**Rezoning Transportation Analysis**  
**Petition Number: Insert Zoning Petition #2021-232**  
*General Location Identifier: 15717307*

**Revision Log:**

Date	Description
02-17-2022	First Review (WB)

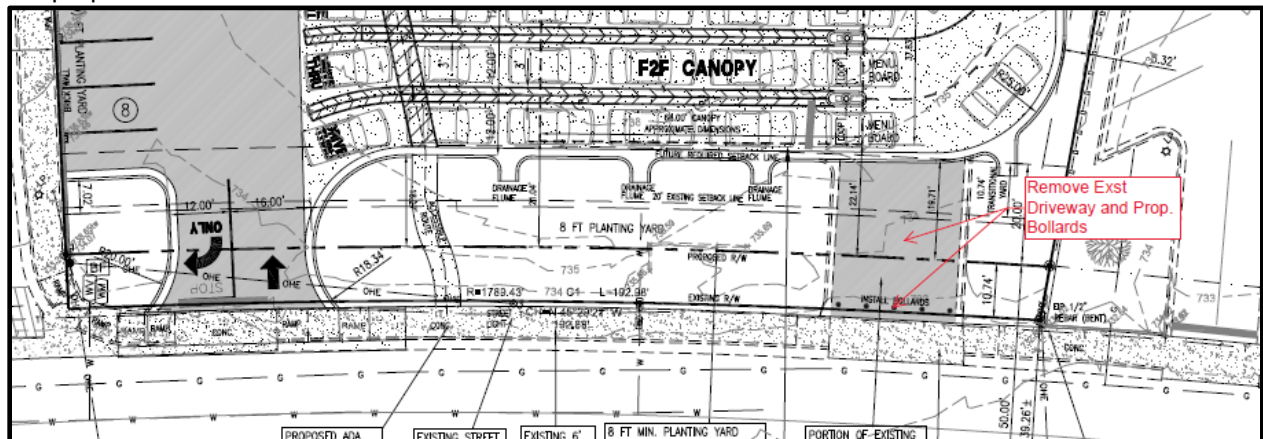
**1. Traffic Study:**

A Traffic Technical Memorandum (TTM) is necessary to include a queueing analysis for the complete review of this petition due to the site being along a high injury network area, within a high congestion location, and for ingress/egress concerns that are triggered by the proposed site configuration.

2. Revise site plan and conditional notes to commit to dedicate 50 feet of right-of-way from the Randolph Road centerline. The site plan shall label and dimension the right-of-way from the road centerline.

3. Revise site plan and conditional notes to commit to construct an 8-foot sidewalk with an 8-foot planting strip on Randolph Road per Chapter 19. The site plan shall label and dimension both items from the back of curb and gutter.

4. Revise site plan to provide a minimum of a 100-foot driveway stem, measured from the back of the driveway apron, into the subject site in accordance with the City's Driveway Regulations.

5. Revise site plan and conditional notes to provide an SUE (sidewalk utility easement) located 6-feet behind the propose 8-foot sidewalk to accommodate the installation of a future 12-foot multi-use path to meet the Charlotte BIKES Policy.

6. Revise site plan and conditional notes to commit to the complete removal of the existing driveway and proposed bollards.

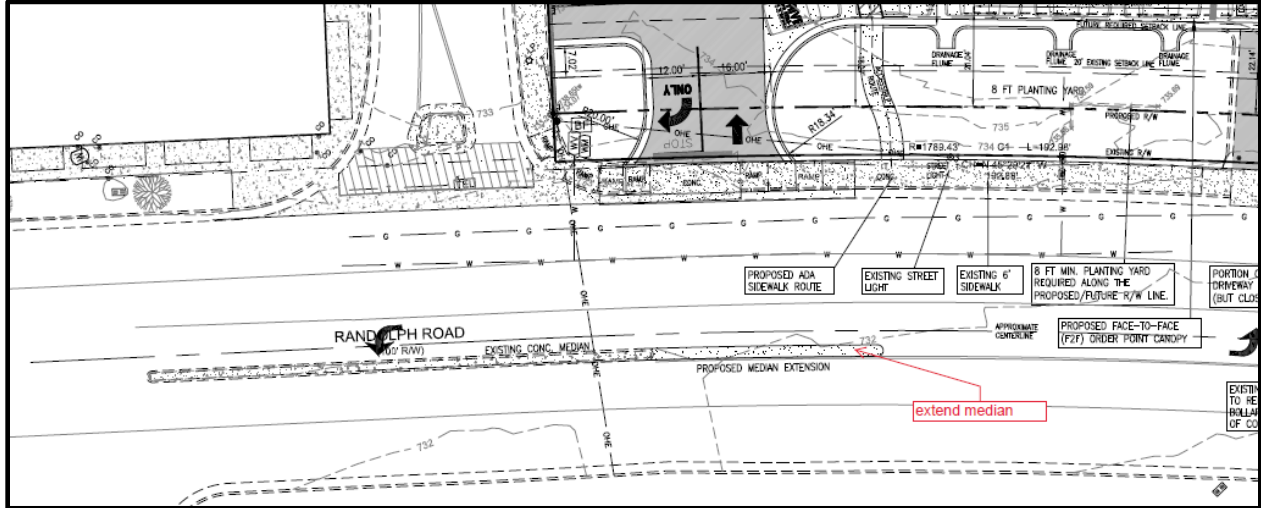
7. Revise site plan and conditional notes to extend the existing concrete median on Randolph Road to a 50-foot offset from the driveway's curb return.

8. Add a site plan note(s) specifying dedication and fee simple conveyance of all rights-of-way to the City before the site's first building certificate of occupancy is issued as needed. CDOT requests rights-of-way set at 2' behind back of sidewalk where feasible.
9. Add a site plan note specifying that all transportation improvements will be approved and constructed before the site's first building certificate of occupancy is issued as needed. The petitioner may phase transportation improvements if said improvements and phasing are explicitly described in site plan notes.
